## **RESOLUTION NO. 25-04**

### **A RESOLUTION OF THE TOWN COUNCIL OF THE TOWN OF RIDGWAY, COLORADO, AMENDING THE TOWN OF RIDGWAY STANDARD SPECIFICATION AND TYPICAL DRAWINGS FOR INFRASTRUCTURE CONSTRUCTION**

**TOWN OF RIDGWAY STANDARD SPECIFICATION AND TYPICAL DRAWINGS  
FOR INFRASTRUCTURE CONSTRUCTION**

**ADDENDUM #1 – FEBRUARY 12, 2025**

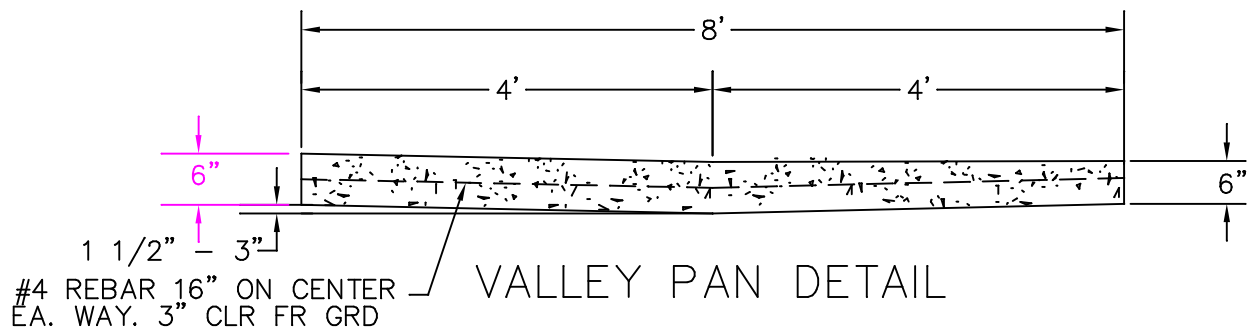
- Section 03250 – Streets – Page 03250 – 6: Removed the bottom 2/3;s of the table to remove redundancy in testing requirements.
- Section 03250 – Streets – Page 03250 – 20: Added new subsection 27 Pavement Markings. That reads:

Striping – Material for striping shall be a modified epoxy meeting the requirement of CDOT 713.17 on the CDOT approved product list. Striping shall be completed in accordance with the approved design drawings, CDOT section 627.05 and other applicable CDOT standards and manufacturer’s recommendations.

Words and Symbols – Material for markings other than striping shall be from Preform Plastic Type I (permanent) meeting the requirements of CDOT 713.13 and listed on the CDOT approved product list. Work shall be completed in accordance with the approved design drawings, applicable CDOT standards including but not limited to sections 627.08, and manufacturer’s recommendations.

Retroreflectivity of pavement markings shall be tested in accordance with CDOT 105.03 (a). If retroreflectivity reading in less than 175, the epoxy shall be removed and replaced. Retroreflectivity of all materials shall meet the requirements of CDOT 713 and other relevant CDOT standards and applied consistent with CDOT standards and manufacturer’s recommendations.

CHK:	TOWN OF RIDGWAY
DATE: 2/25	CONSOLIDATED CONSULTING SERVICES PO BOX 738, DELTA, CO 81416
DRN: R_TYP	
	VALLEY PAN DETAIL

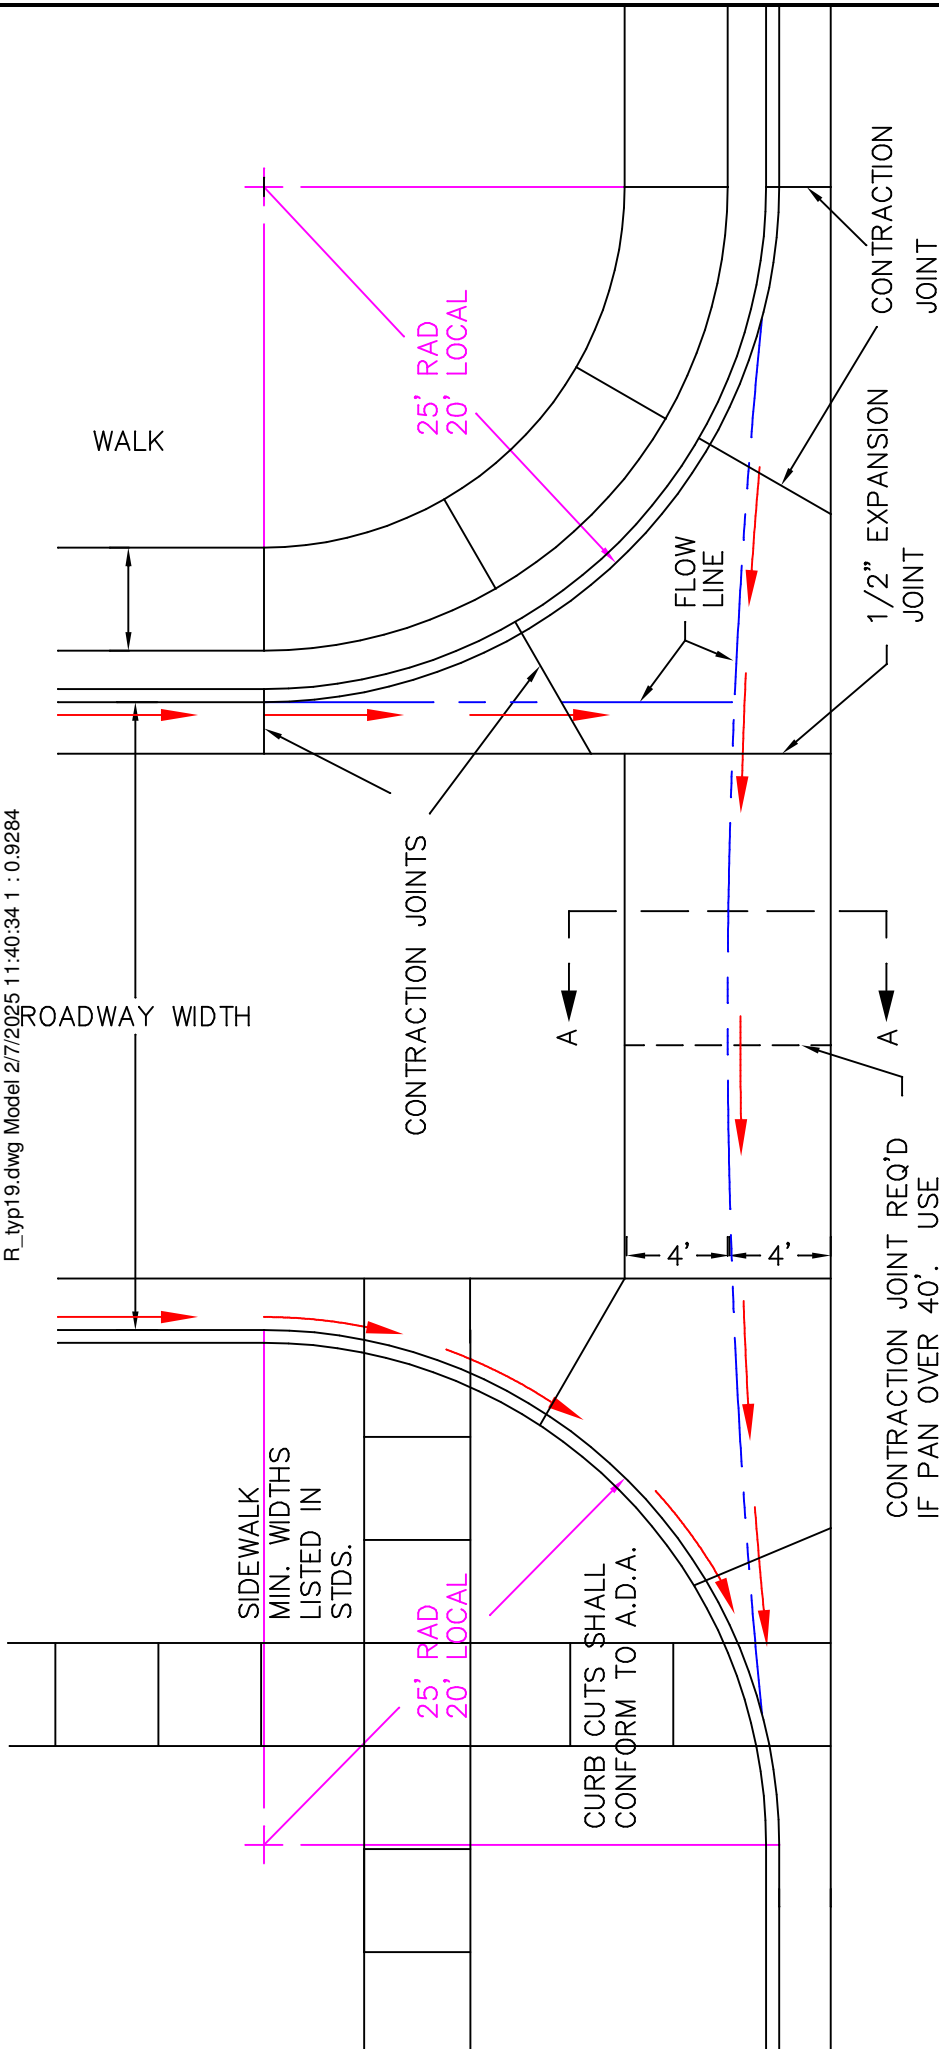
- Typical Drawing – Valley Pan Detail – Modify the reinforcement from welded wire to #4 rebar on 16” center.
- Typical Drawing - Intersection Gutters Detail - Modify the reinforcement from welded wire to #4 rebar on 16” center.
